Agenda Item #2

Application 2025-30-CA

After-the-fact window and column replacement on façade; Paint applied to brick porch wall

APPLICATION NUMBER <u>2</u> DATE <u>6/18/2025</u>	
APPLICANT <u>1818 Design, LLC</u>	
PROJECT <u>After-the-fact window and column replacement on façade; Paint applied to brick porch wall</u>

SOUTH ELEVATION
SCALE 1/4"=1'-0"

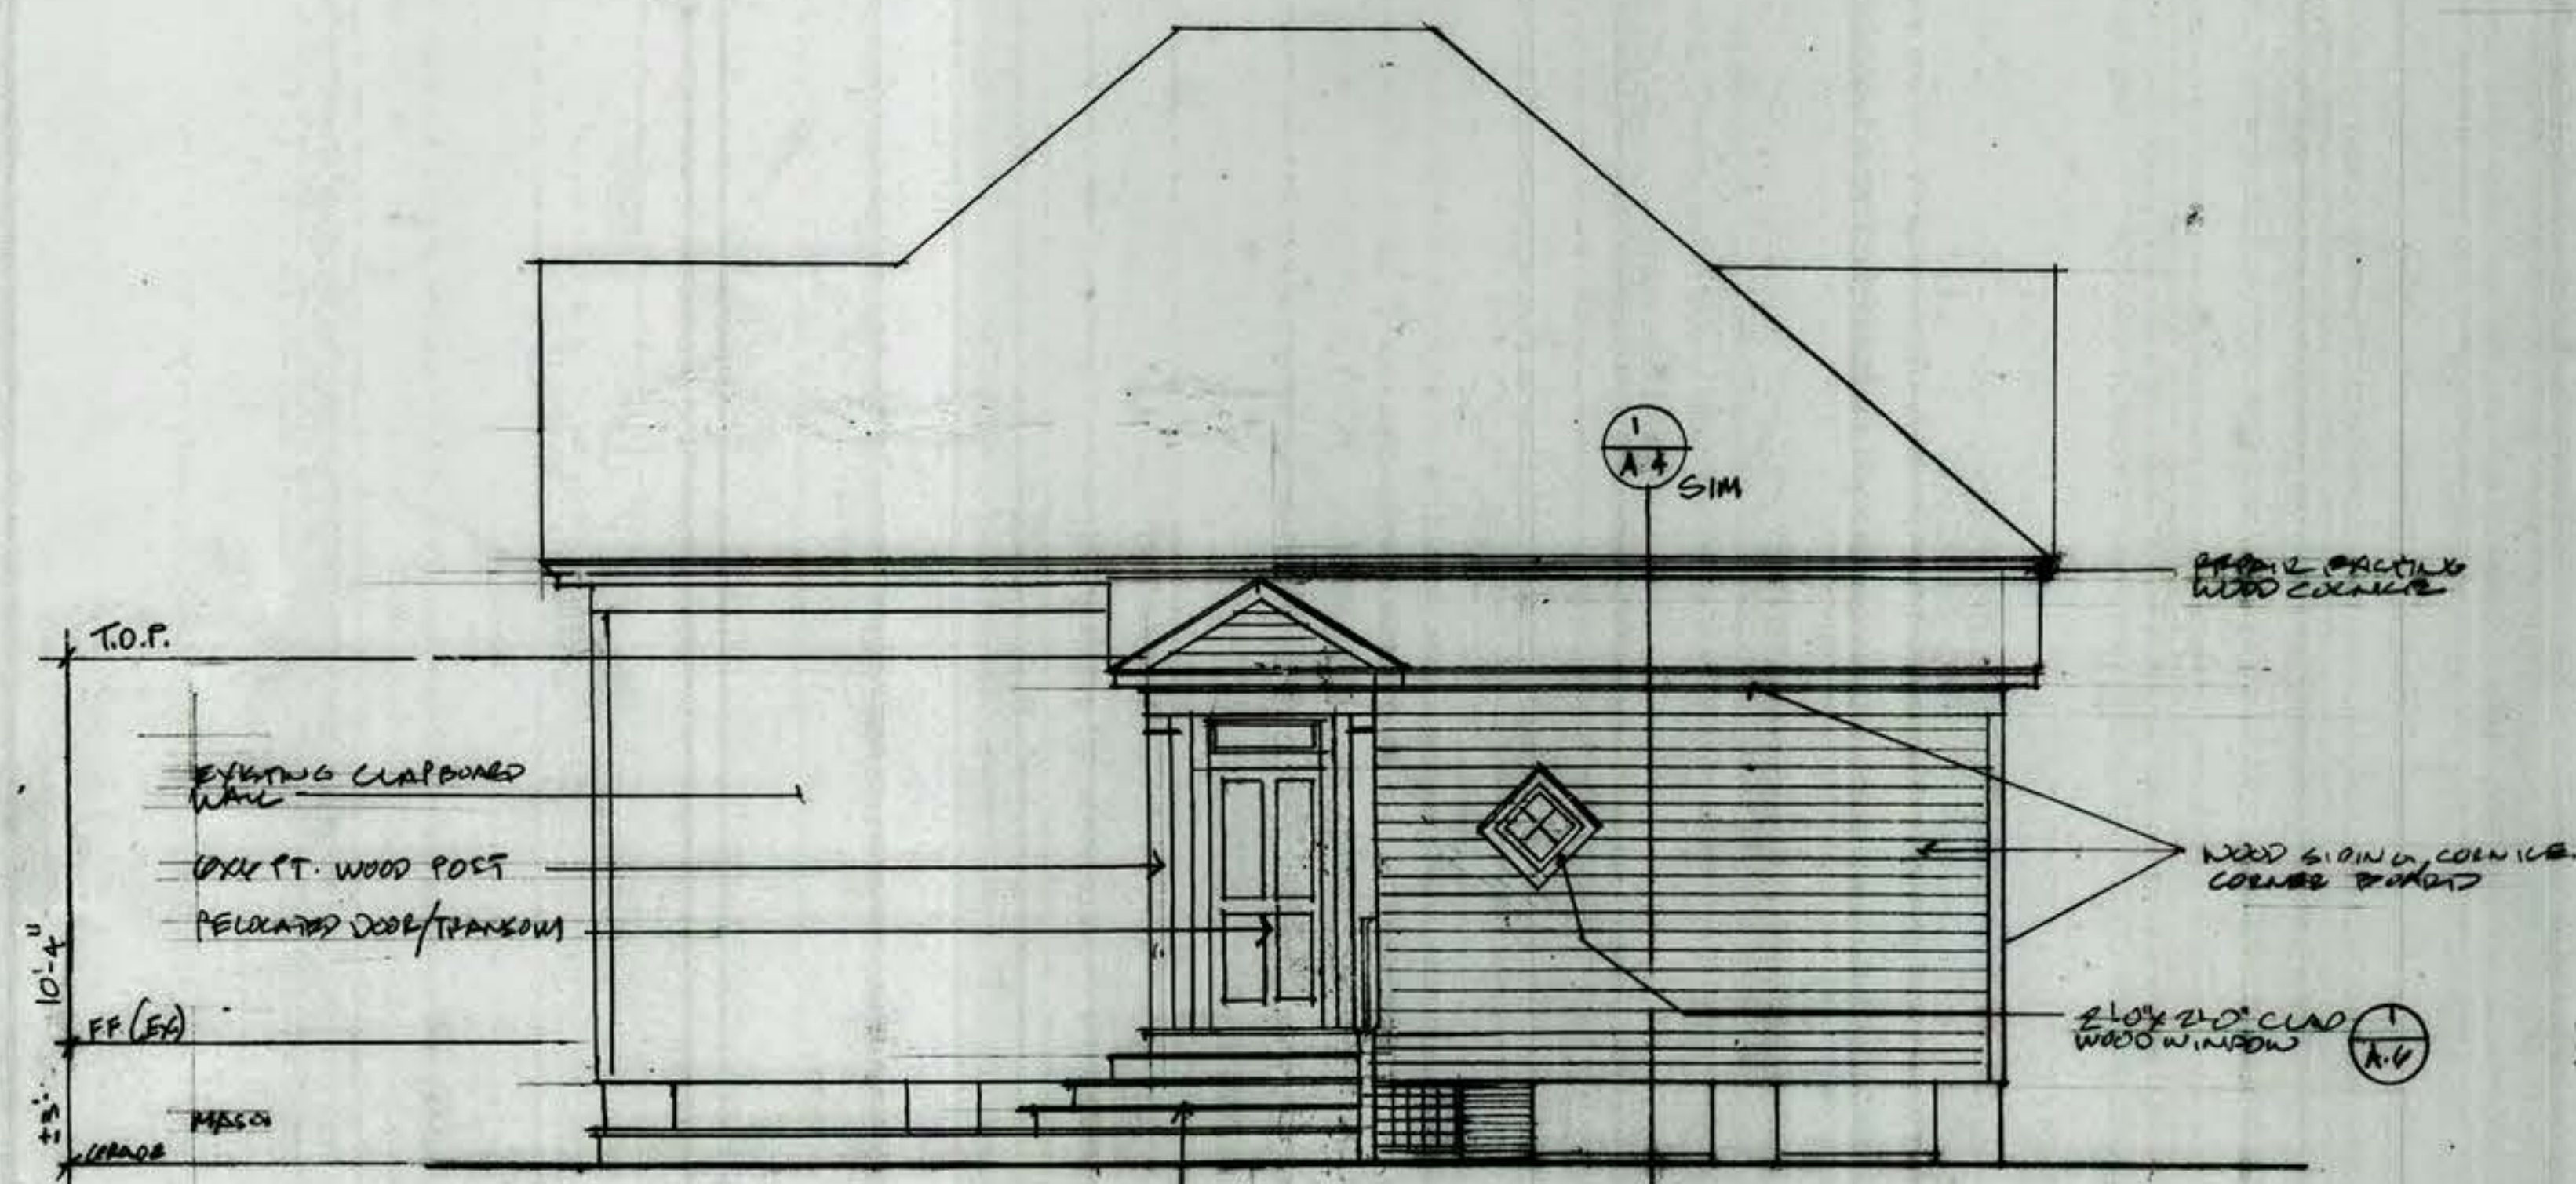
The replacement window arrangement installed in each of the box head window openings consists of a wood one-over-one window below a lintel board, with a fixed single-light window above. This is an inappropriate alternative to the full-length window previously extant in these openings and considerably alters the stylistic expression of the façade.

The current replacement columns lack the dimensionality provided by the taper and the paneling seen on the original columns in historic photographs. The use of Hardie board, though not congruent with what was submitted by the applicant, is a suitable replacement material as noted in guideline 5.19 above; however, the flatter profile of the replacement columns produces an overall look of inferior craftsmanship and does not appropriately convey the craftsman styling of the historic porch. (5.3, 5.4, 5.6)

North Elevation, Left Window– Replace window

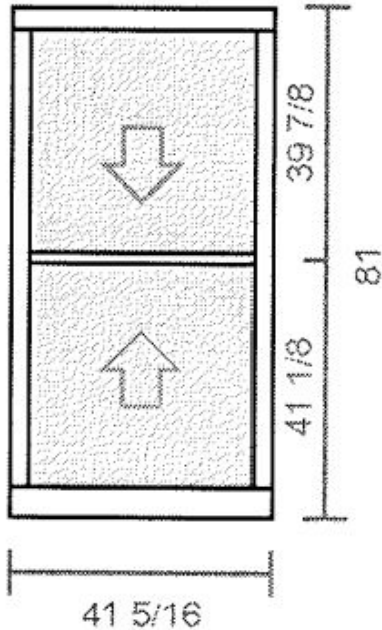
During the site visit, historic windows were found on the property. These windows appear to be the original box head windows removed from the façade, and potentially those from the bay window as well. The windows seem to be in good repairable condition. Also discovered was a dumpster containing removed trim.
